ROLLIN RIDGE Filing No. 1 Grading & Erosion Control El Paso County

"RECORD DRAWINGS"
REVISED TO CONFORM WITH
CONSTRUCTION RECORDS
8/26/22

ROLLIN RIDGE ESTATES - FILING NO. 1

**GEC PLAN
TITLE SHEET**

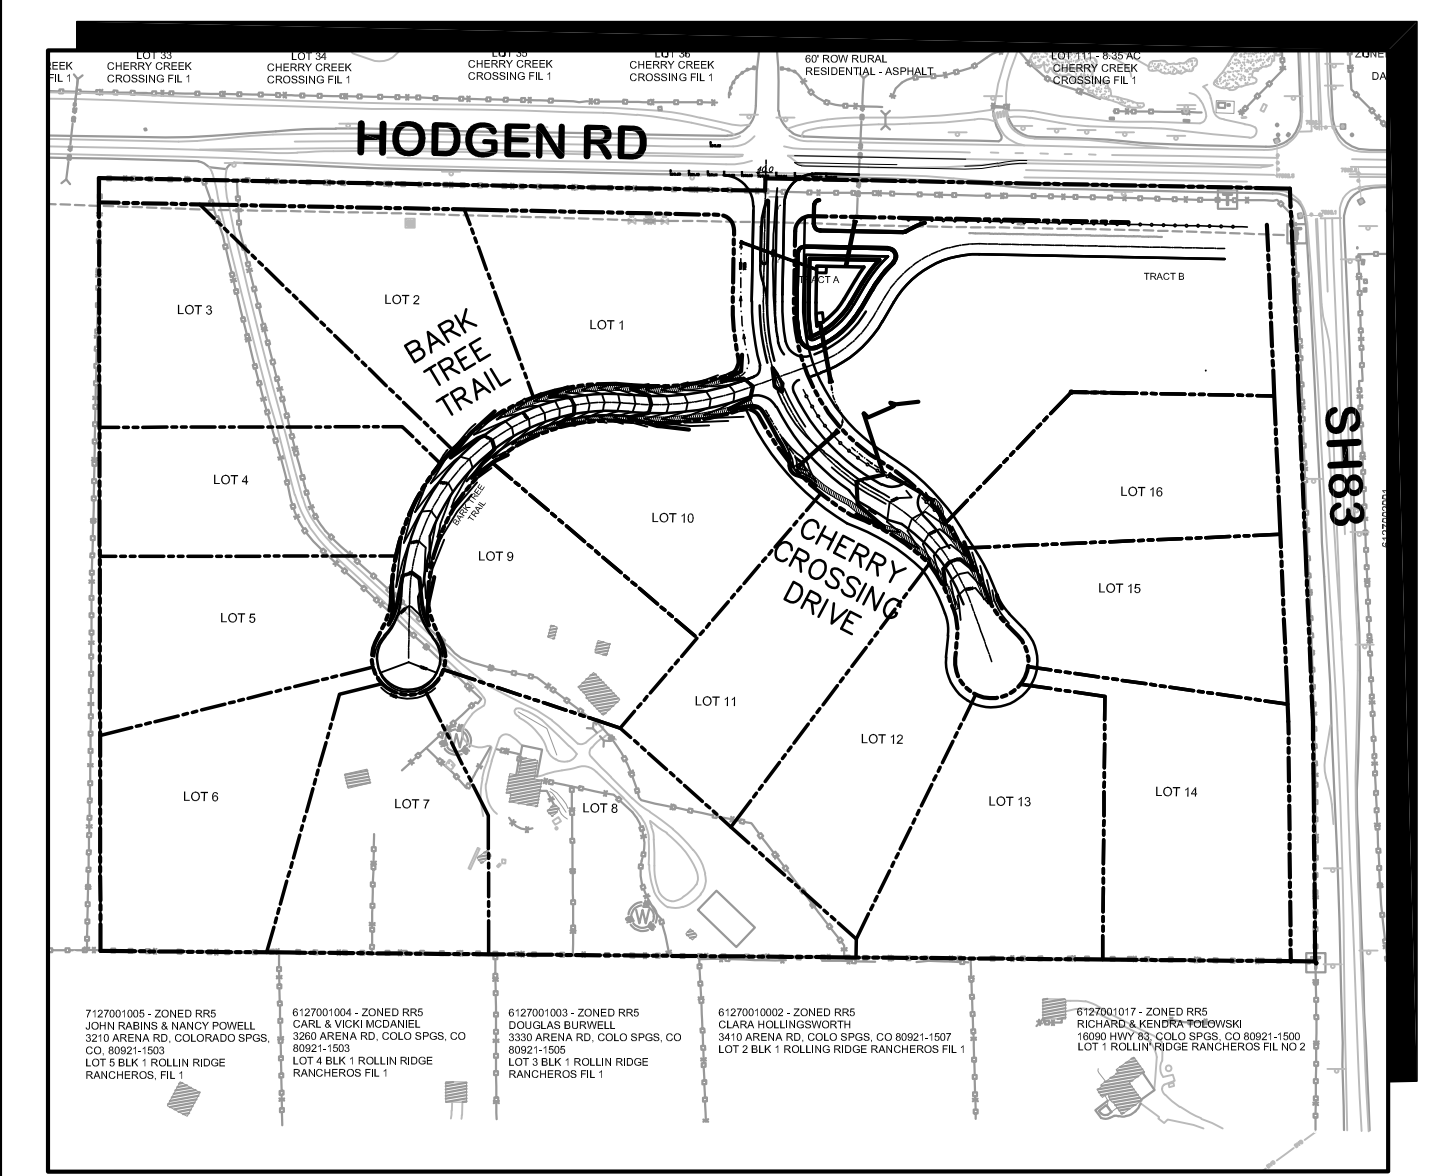
Submit As-built of the Street Construction Drawings and Signage and Striping Plans per ECM 5.10.6

Replace with the approved CDs. Per ECM 5.10.6.B the revisions shall be shown on a copy of the original approved construction plans

Alternative is to stamp/sign all sheets that were revised from the original approved documents.

Update to "Engineering Record Drawings"
